# **Monterey Avenue Skate Park**

*SCH# 2015062067*

# FINAL ENVIRONMENTAL IMPACT REPORT

## MONTEREY AVENUE SKATE PARK STATE CLEARINGHOUSE #2015062067

**G** BIO-SWALE DETAIL NTS  
**SP6**

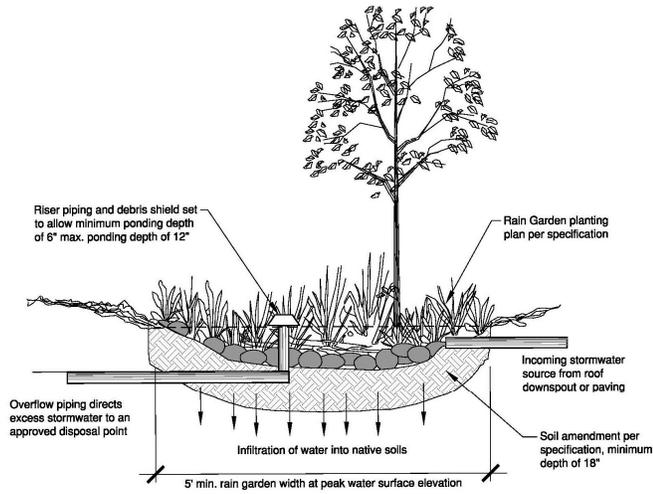
- 3A-4 Skateboard Contamination and Drainage Biowale. The comment suggests contaminants off skateboards and other surfaces must pass through a bioswale and asks about the construction and design of the bioswale. The comment does not address the EIR or its analyses, and no response is required. Proposed stormwater improvements are shown on revised project plans which may be accessed on the City's website at the link below.  
<http://www.cityofcapitola.org/communitydevelopment/page/proposed-monterey-avenue-skate-park>

- 4-12 Drainage Plan. The comment indicates that the stormwater Best Management practices are not explained in the EIR, such as a bioswale that may be required of the project as indicated on pages 4.2-6 and 4.2-7 of the DEIR. Details of the drainage system, including the bioswale, typically are included on the final plans submitted at as part of the building permit application. However, during the public review period, minor changes to the site plan were made, including showing the location and a design detail of the bioswale. See the CHANGES TO DRAFT EIR (3.0) subsection of this document.

The project is designed with a 120-foot long, 6-inch PVC storm drain that traverses the on the bottom of the facility as shown on Figure 2-4. The preliminary plans propose connecting the project site storm drain to an existing 12-inch storm drain just west of the site. Preliminary City staff review indicates that the proposed storm drain is adequate to serve the proposed project. ~~However, City staff review indicates that the Project plans have been revised and show will be required to revise project plans to provide a drainage bioswale or other low impact development feature along the southern portion of the site to pre-treat runoff prior to discharging into the City’s storm drain for compliance with the City’s stormwater requirements. See the new Figure 2-1A at the end of this section for location of the bioswale. The design is shown below. (See Impact 4.2-2 below for further discussion.) Additionally,~~ According to City staff, the existing downstream storm drain has capacity to serve the project, and ~~increased~~ runoff from the project to site would not exceed capacity of existing drainage facilities during a 10-year storm or cause offsite drainage problems. However, in accordance with City General Plan Policy OSC-8.9, post-project peak stormwater flows will not exceed pre-construction conditions.

bioswales are shallow and vegetated and would appear to be part of the overall landscaping. A revised site plan now shows the location of the bioswale at the southern edge of the project between the skate park and a planned retaining wall, and a design detail has been provided. See CHANGES TO DRAFT EIR (3.0) section of this document.
